Design Review Board

Meeting Minutes

Mesa City Council Chambers - Lower Level, 20 East Main Street
Date: December 9, 2025 Time: 4:30 p.m.

Elevations

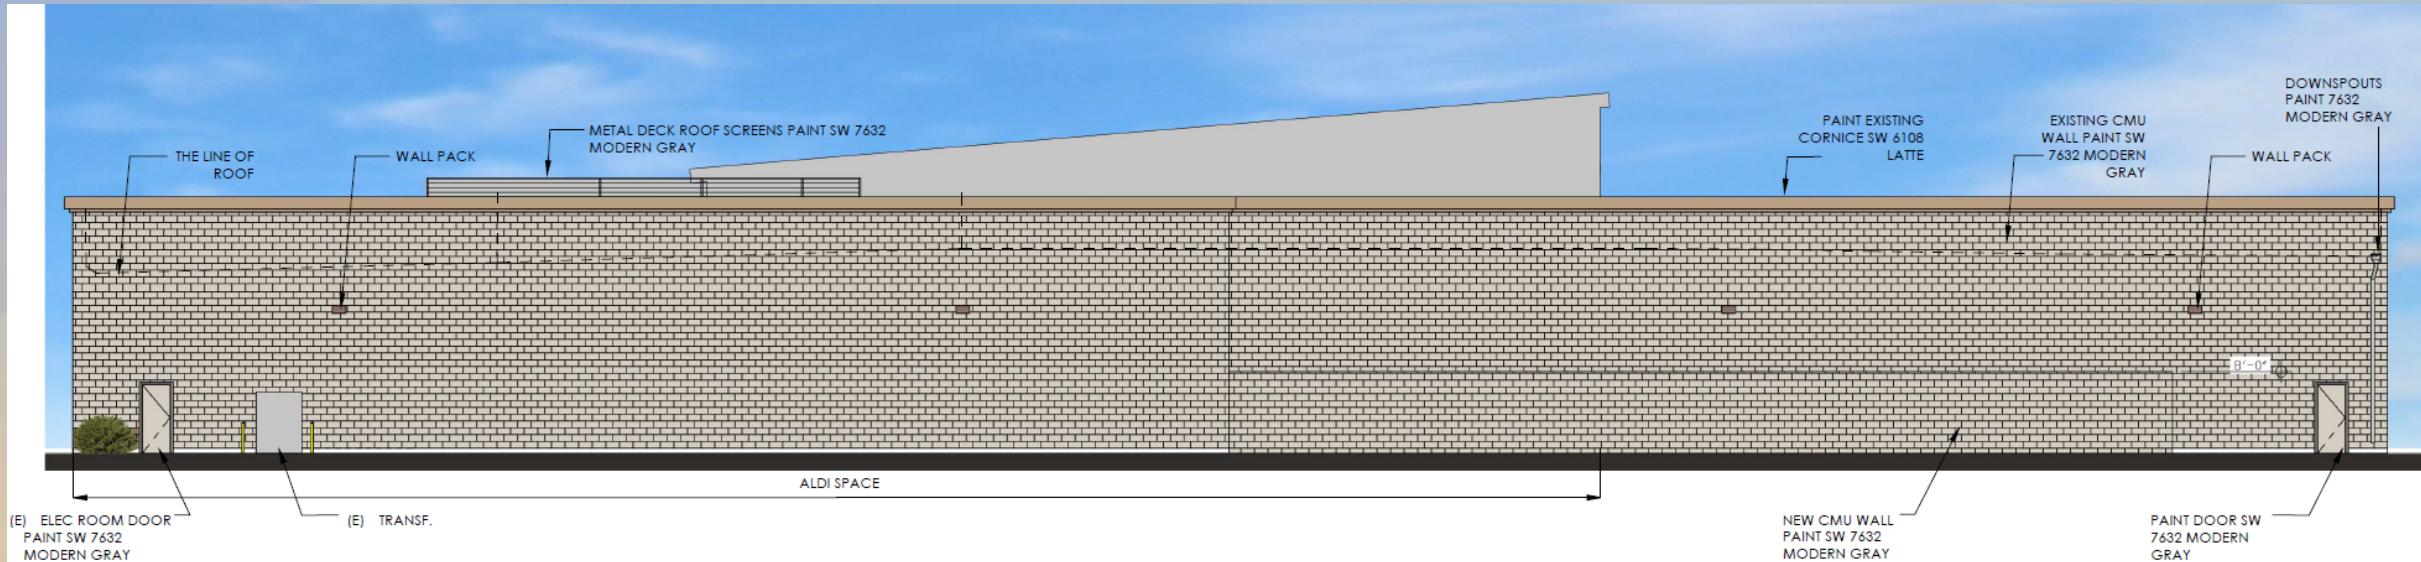
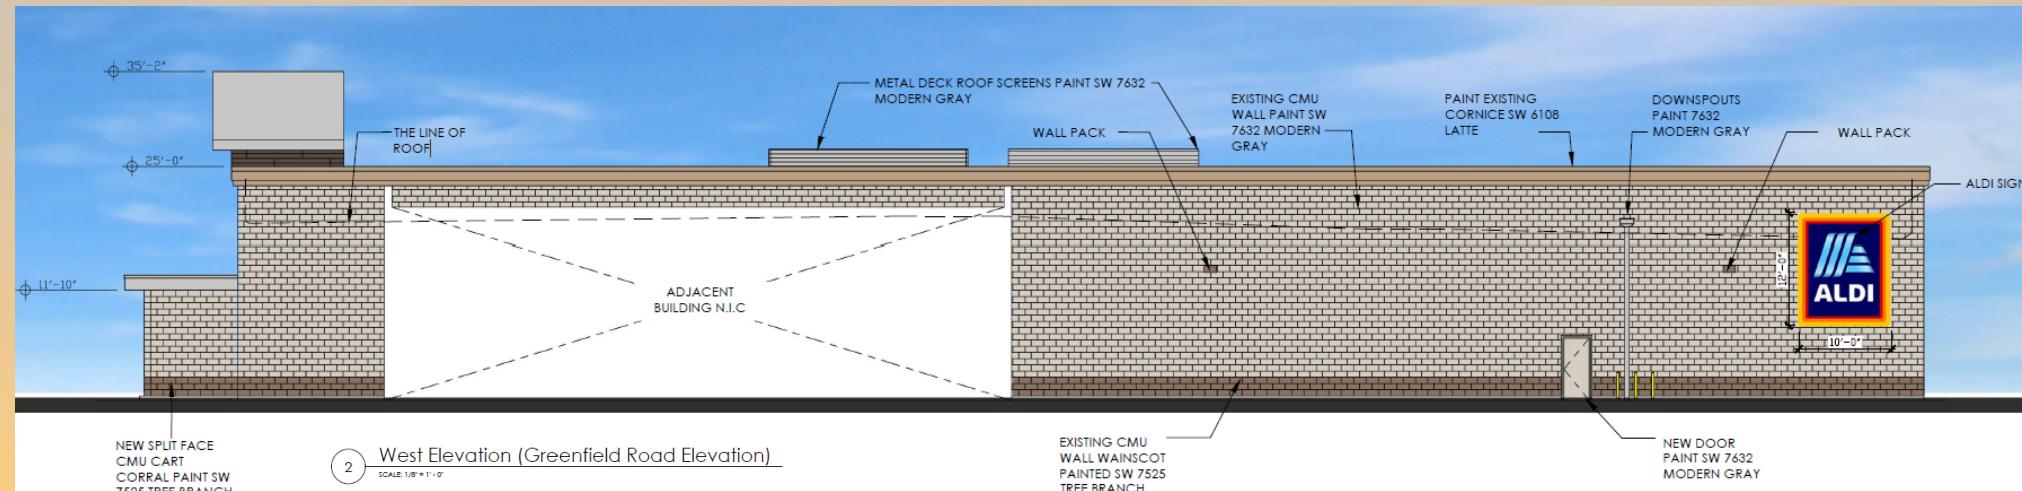
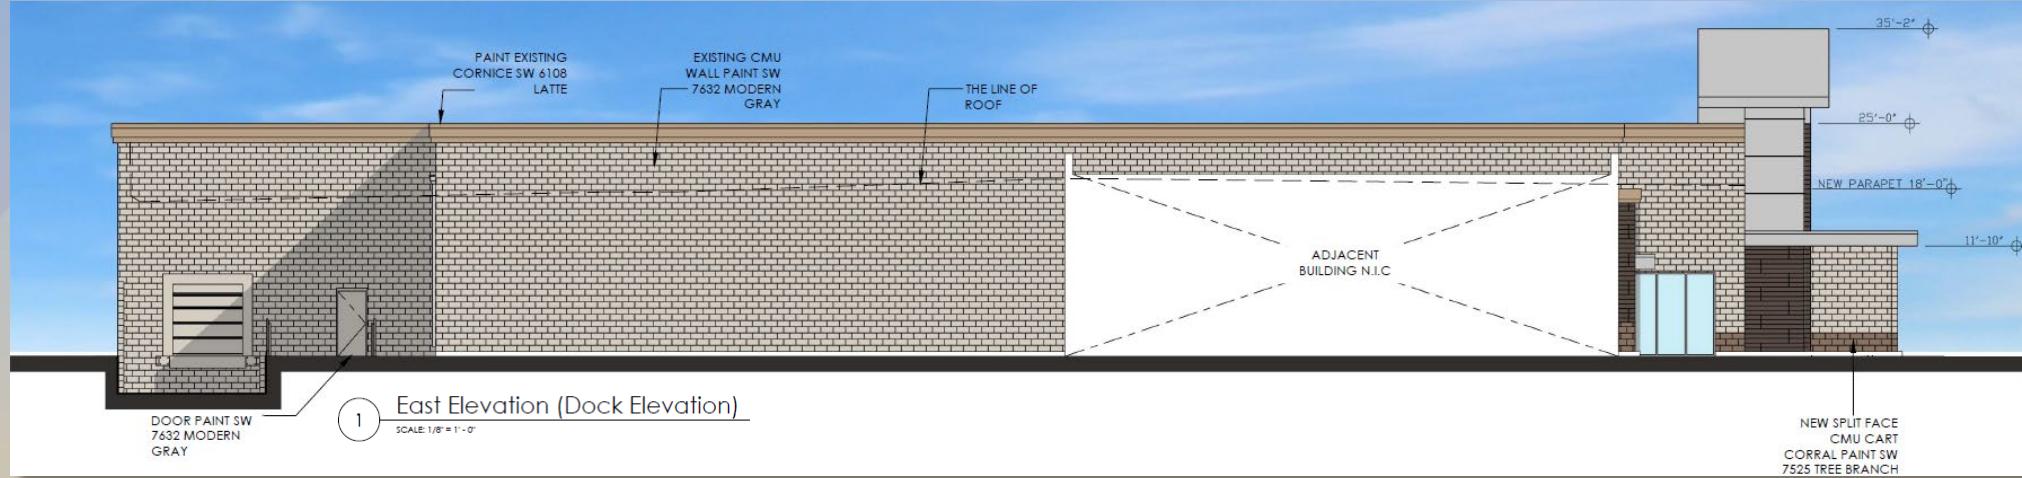
1. Compliance with Ordinance No. 1273, except as modified by subsequent approvals.
2. Compliance with all requirements of Design Review Case No. DRB25-00647.
3. Compliance with all applicable City development codes and regulations.
4. Prior to the issuance of a building permit, submit for and receive approval of an Administrative Review for minor site plan modifications.
5. Prior to submittal of a building permit, submit to planning staff revised elevations to continue the painted CMU wainscot along the west, north and east elevations

Elevations

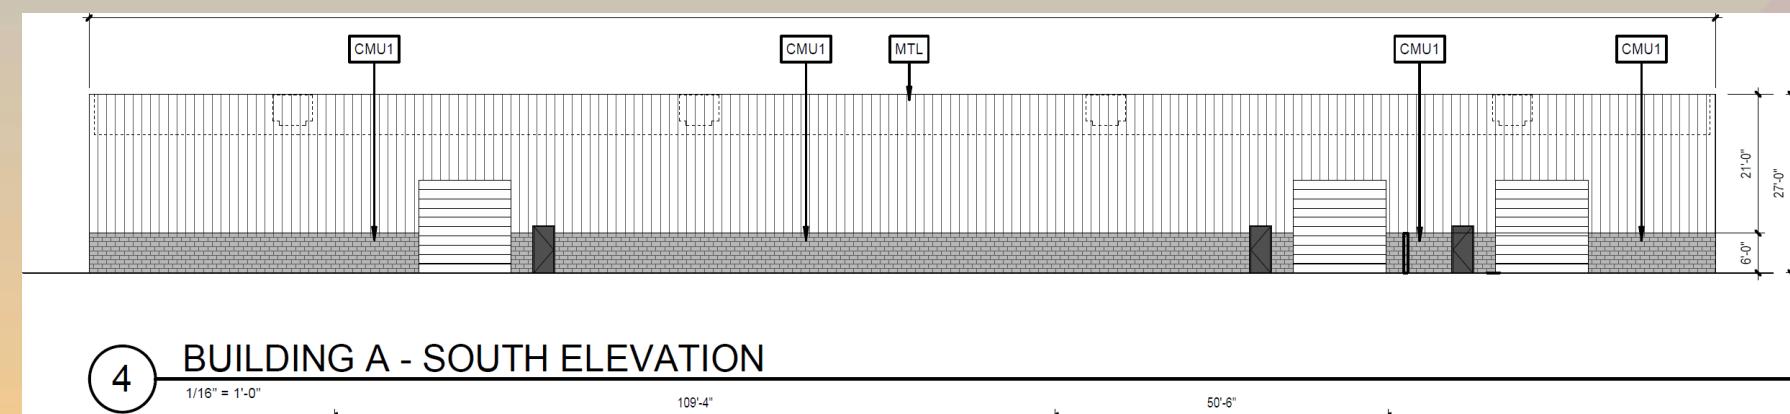
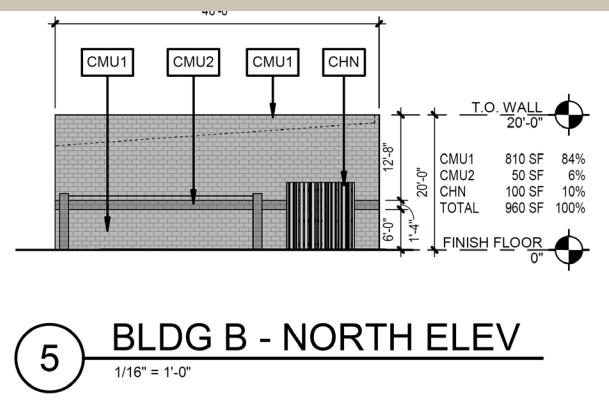
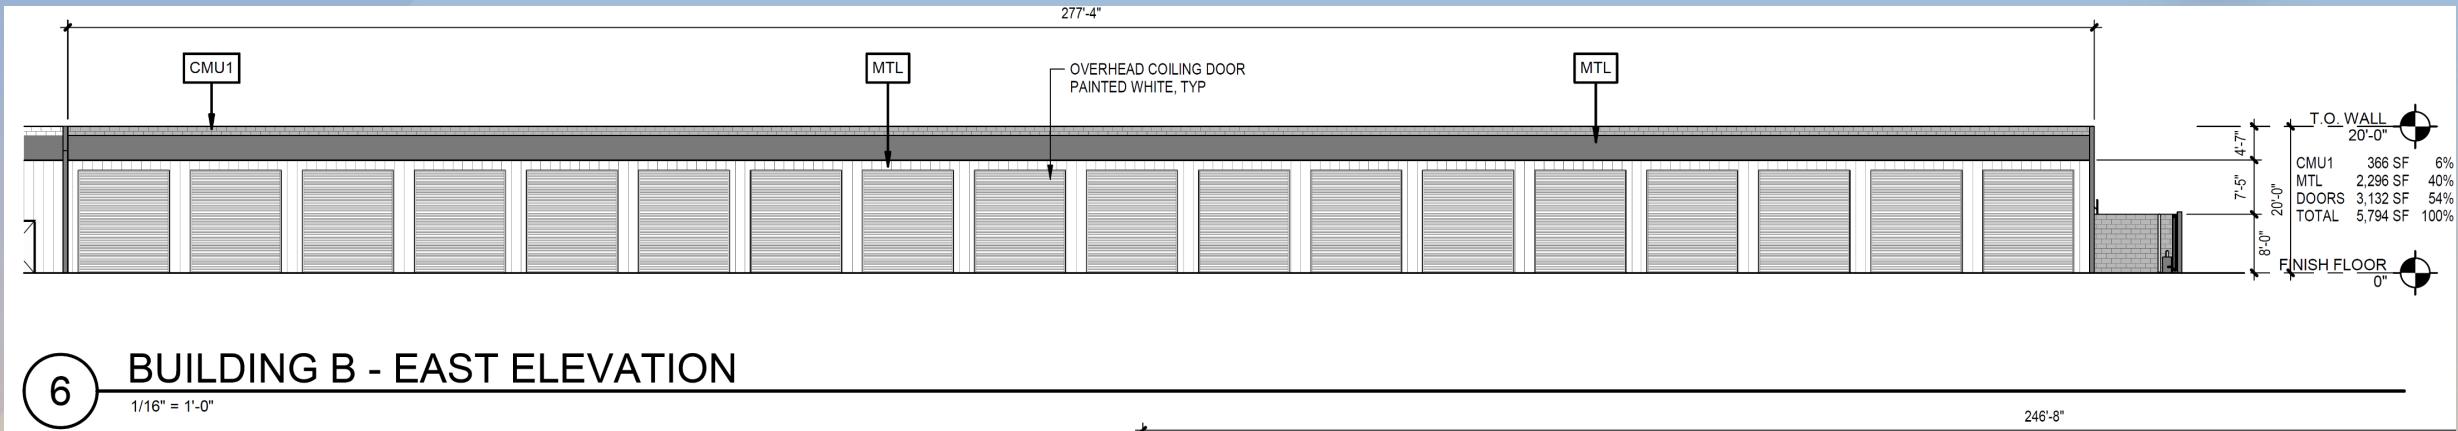
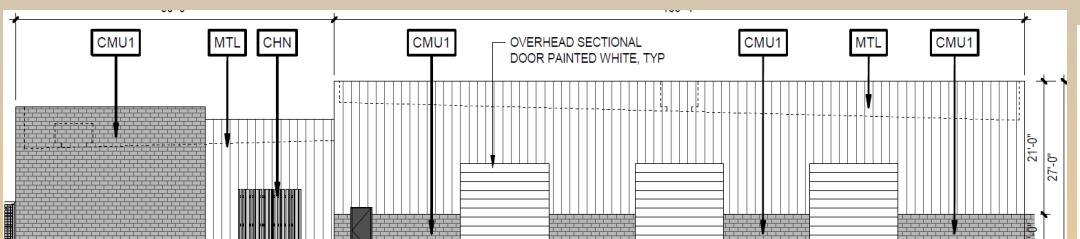
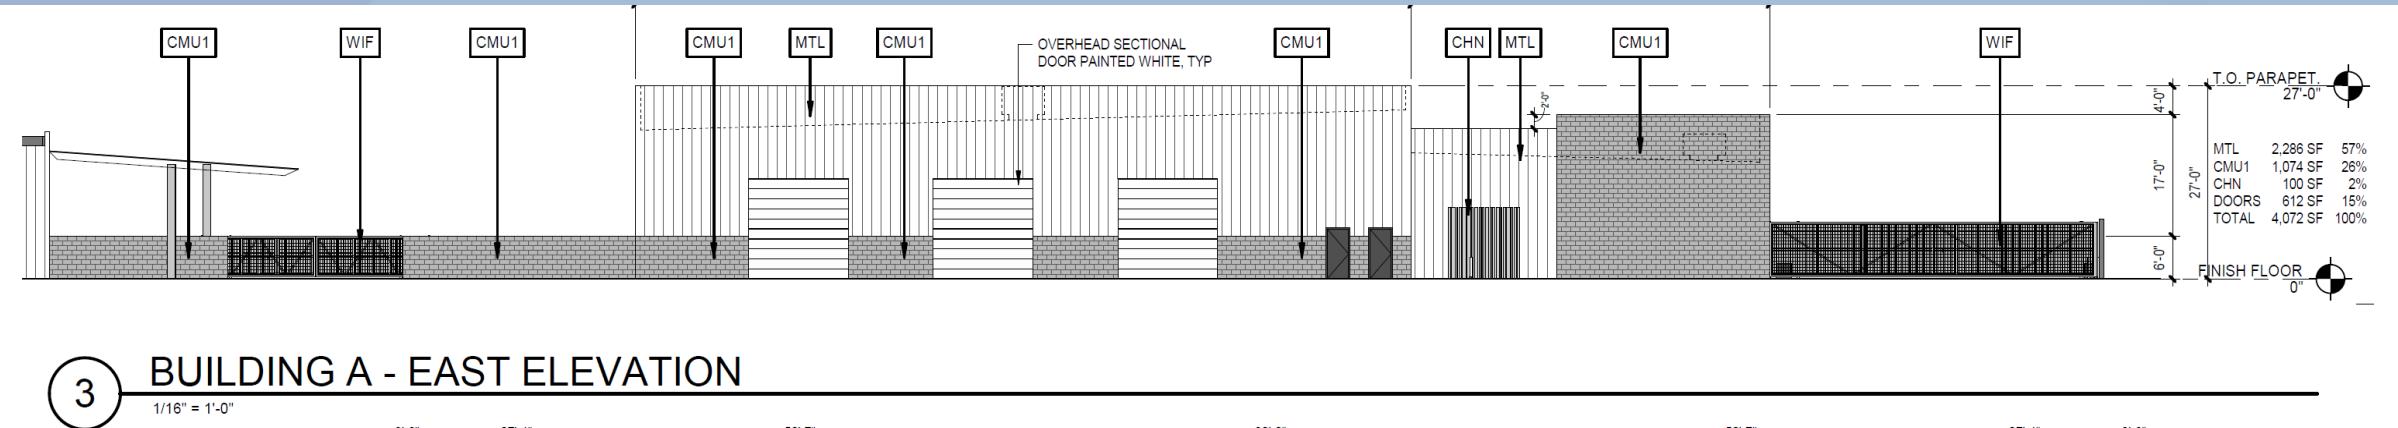
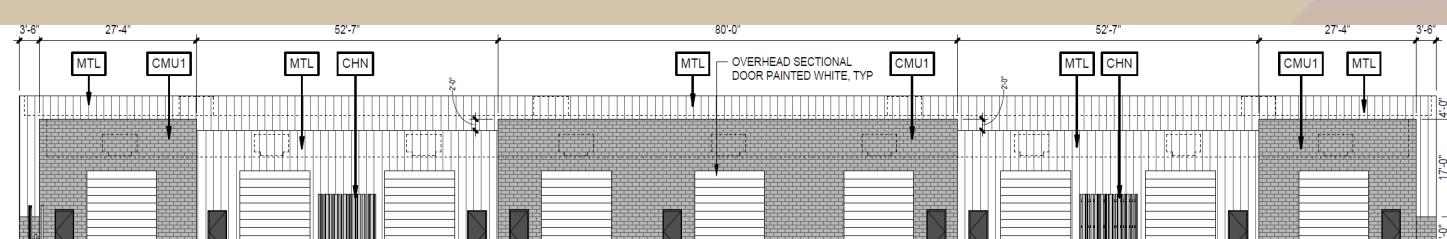
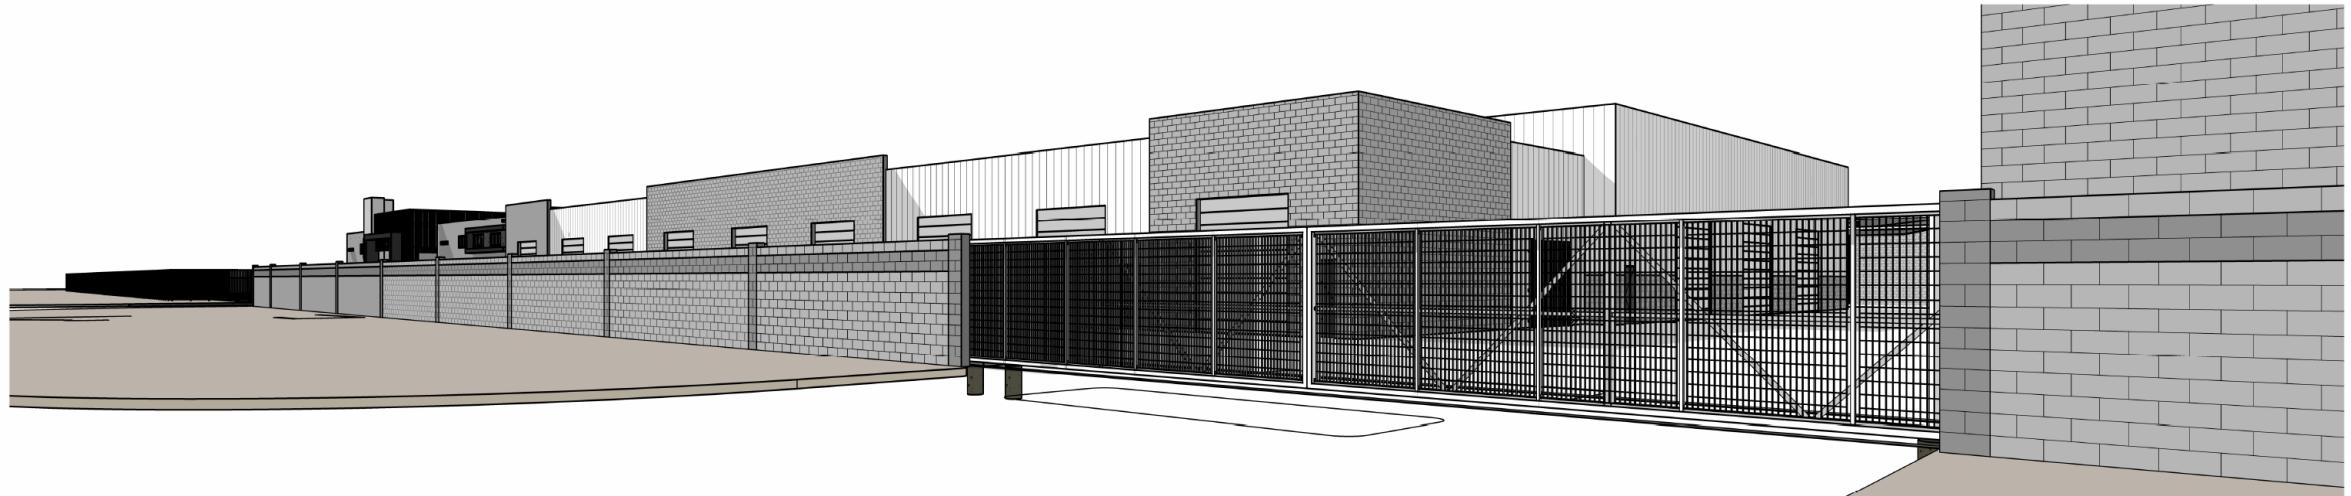
- Enhance the design of the proposed parapets by increasing the depth of the returns or provide a different material

Landscape Plan

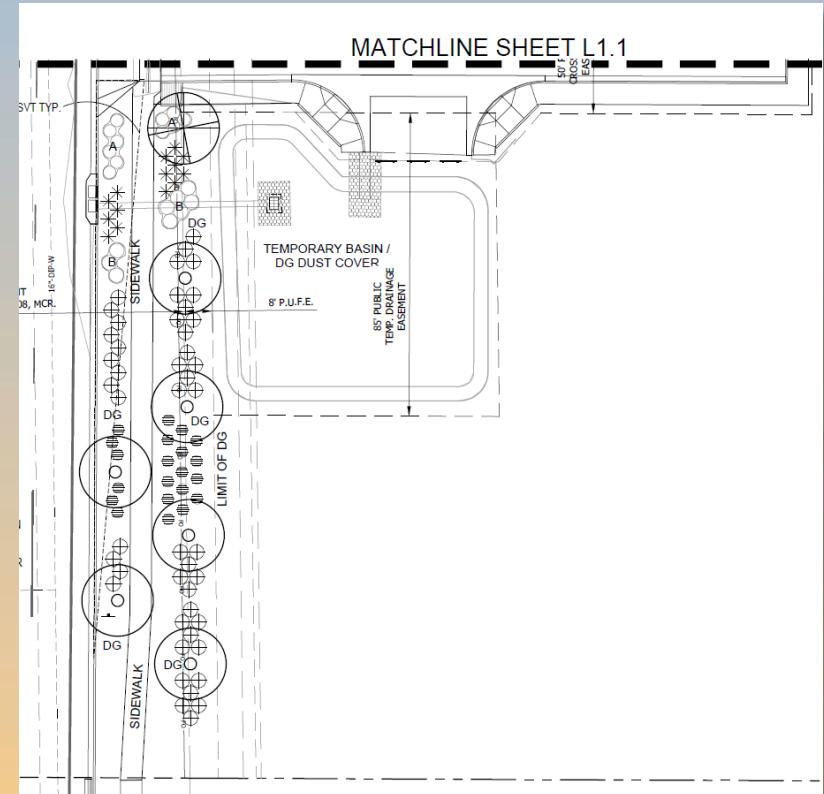
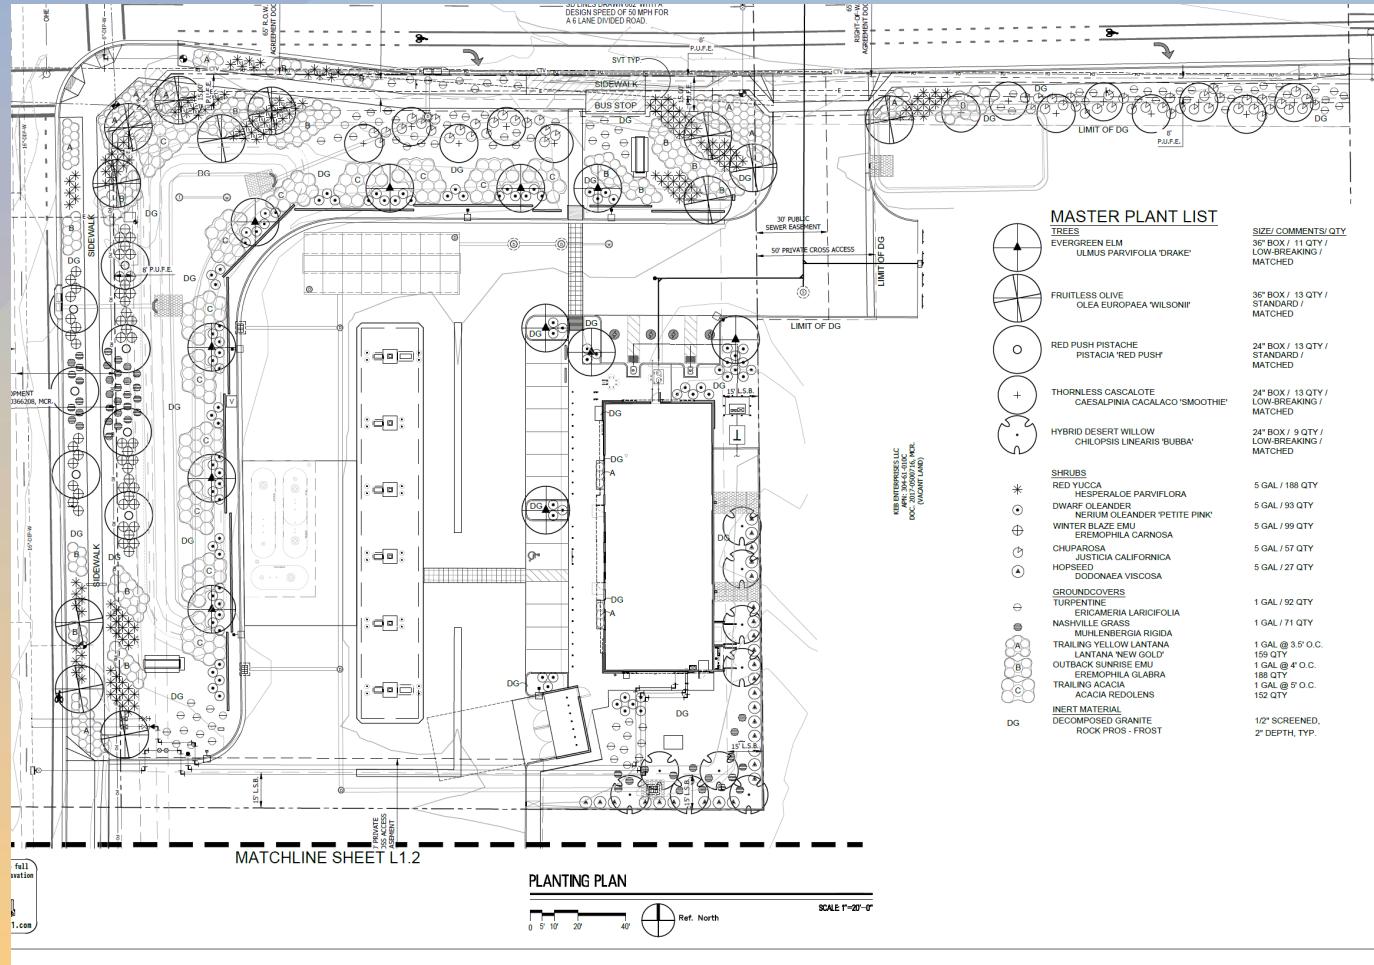
- Provide landscaping around the trash enclosure, specifically immediately south of the enclosure so long as there are no easements of concern
